Product/Process Change Notice (PCN)

PCN #: PCN_WE-STAR-
TEC_20171101_74271131(S)_Capacity Increase

Product Affected: 74271131, 74271131S

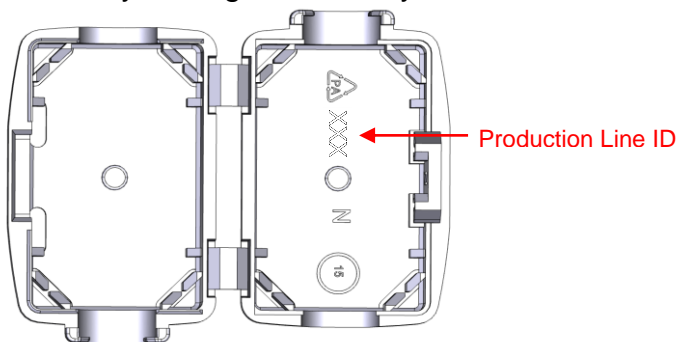
1. Neither electrical nor mechanical properties of the part will be changed.
2. The production lines can be identified by the three digits inside the plastic housing.

Already established production lines of plastic housing:

Digits: 128

Country of Origin: Germany

Digits: 312

Country of Origin: Austria

Additional production line of plastic housing:

Digits: 375

Country of Origin: Germany
